## Montgomery Knolls Elementary School, Mandatory Referral, MR2019017

Completed: 06/18/2019

- Mandatory Referral to construct a bus loop entrance along Daleview Drive with additional parking, modify green field and relocate hard surface play areas;
- Current use: public elementary school;
- Located at 807 Daleview Drive in Silver Spring;
- 10.33-acre site zoned R-60 in the *2000 Silver Spring East Master Plan* area;
- Applicant: Montgomery County Public Schools; and
- Acceptance Date: May 9, 2019.

Figure 4: Site Plan Proposal

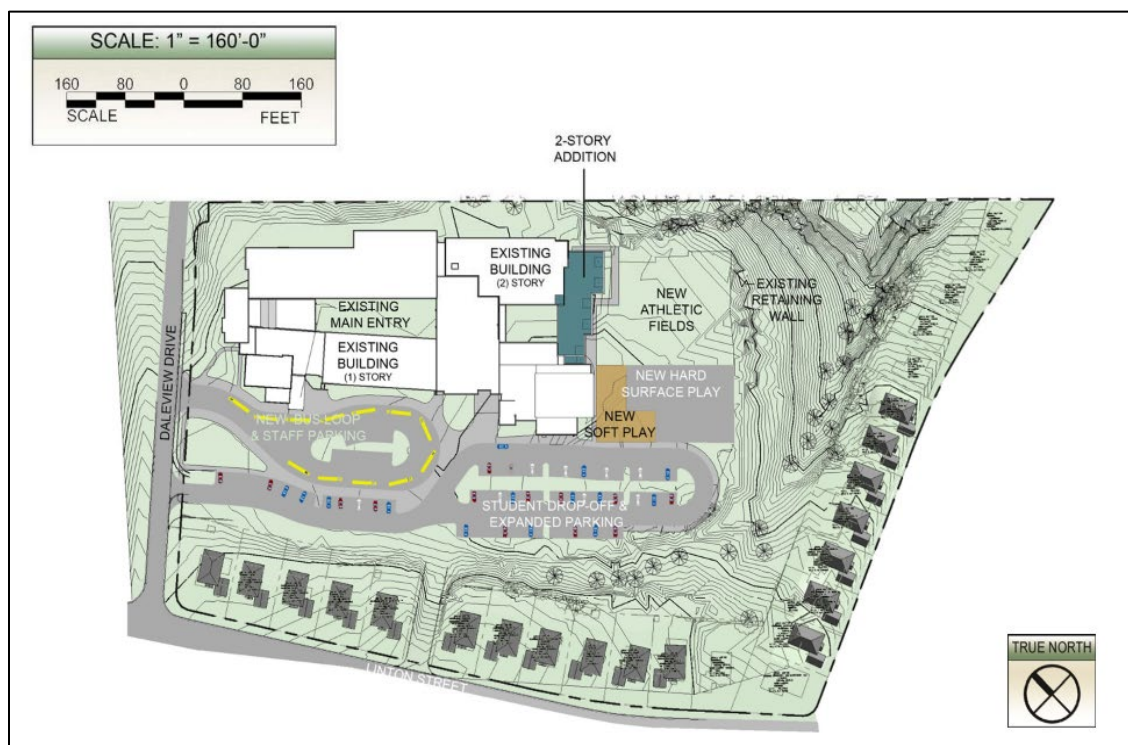
An alternative site design that does not reduce useable grass play area would be preferred on the site. Consider reconfiguring portions of the one-story building into multi-story structures, similar to the phase 1 recently approved addition, to free up more site area for play fields. Plan for long-term reconfiguration of the entire site to more efficiently use land with a compact multi-story school building.

Sidewalks along the school frontage should be at least 5-feet in width. Buffers should be no narrower than 6 feet, such that street trees can thrive. The trail on the school site should be widened to at least 10 feet, as recommended by the Bicycle Facility Design Toolkit, an appendix to the *2018 Bicycle Master Plan*. The school owns right-of-way on Linton Street between two private parcels which provides access for pedestrians and bicyclists to the site. No changes or improvements are recently approved as part of this mandatory referral application.

Figure 5: Proposed Parking Lot Configuration with Added Entrance

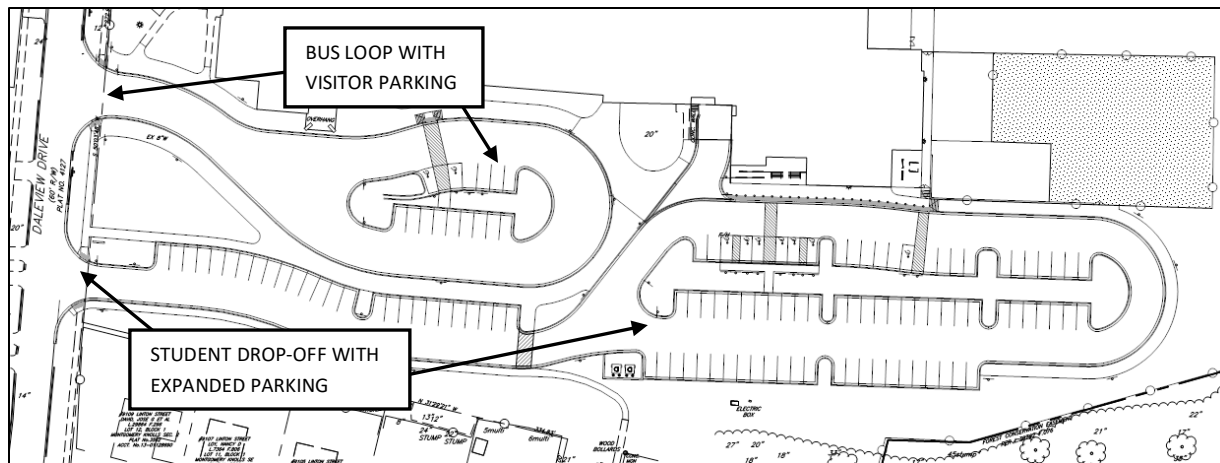
The proposed parking lot configuration (Figure 5) will include a separate bus loop entrance and will accommodate queuing for up to 15 buses on site. The bus loop will also include 13 visitor parking spaces and 2 ADA accessible parking spaces. Staff and visitors will use the existing entrance on Daleview Drive. The application proposes expanding the surface parking lot to accommodate both parking and a new pick-up and drop-off loop to be used exclusively by parents. The parking capacity will increase from 91 to 119 spaces, including 7 additional ADA accessible parking spaces.

MCPS conducted four schematic design meetings with parents, neighbors and staff of Montgomery Knolls Elementary School on May 30, June 14, September 18, October 4 and December 6 of 2018. The proposed parking lot configuration raised the following concerns from within the neighborhood:

- Crossing of bus and car traffic directly in front of the school;
- Neighborhood traffic as a whole;

- Probability of making the intersection of Linton Street and Daleview Drive into a 3-way stop;
- Adding speed bumps to minimize speeding; and
- The increase of vehicle fumes due to new bus and car que.

1. If the distance between the existing driveway and proposed driveway along Daleview Drive is less than 100 foot tangent, the applicant will need to submit and receive approval for a Design Exception prior to issuance of the right-of-way permit.

Figure 6: Proposed Play Areas

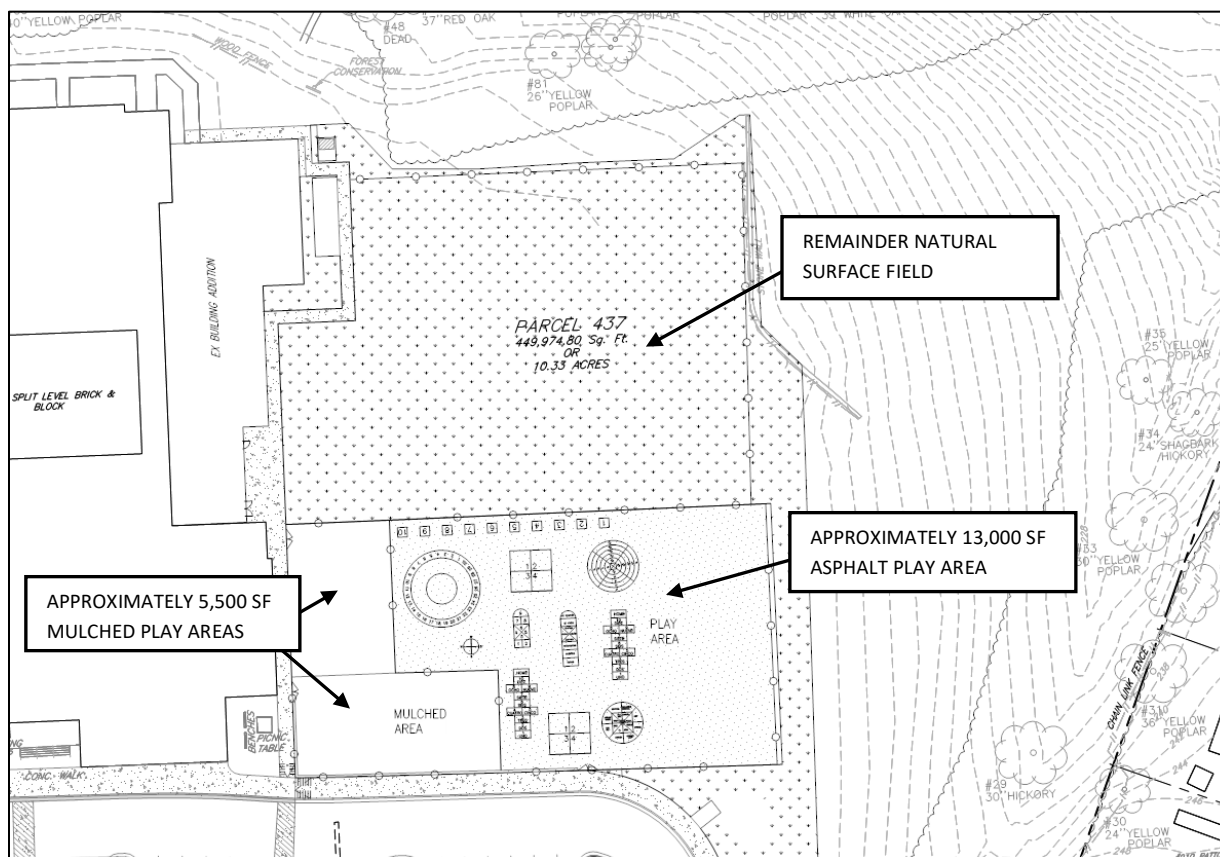
6. Recommend that MCPS provide proper vertical soil profile engineering and a necessary irrigation system to maintain a desirable grass condition in the remaining play area at the rear of the school.

The changes to the parking lots requires the relocation of play areas south of the building addition. The relocation will move the play areas to an area that is currently open field. The new play areas will include 2 mulched play areas and a hard surface play area. As a result of this relocation, the natural surface athletic field will be reduced by almost half to accommodate a curriculum requirement of MCPS to include hard surface play areas. See Figure 6 for proposed play areas.

The Department of Parks had no issues and no comments regarding the school addition that was approved by the Planning Department in February 2019. However, this Mandatory Referral proposes field reduction by approximately 50 percent to accommodate a hard surface play and mulched area relocation. This field is publicly permitted for soccer use through the Community Use of Public Facilities. Such a reduction of field size will diminish existing rectangular field inventory in an already underserved East County. The Parks Recreation and Open Space Plan (October 2017) indicates an existing lack of soccer field inventory in the east county. To replace this field in the same service area, would likely involve 3-4 million dollars associated with acquisition and construction. The Department of Parks does not support the Mandatory Referral and is concerned with the reduction in the number of existing public permitted rectangular fields on school property.

The application involves no ballfield mitigation investment or renovation. The Parks Department believes vertical soil profile engineering and an irrigation system will be necessary to maintain a desirable grass condition in the playing fields for field conditions will diminish as foot traffic is concentrated into a smaller area. They believe field conditions will likely diminish to one where there is very little grass, such as what has occurred at Flora Singer Elementary School.
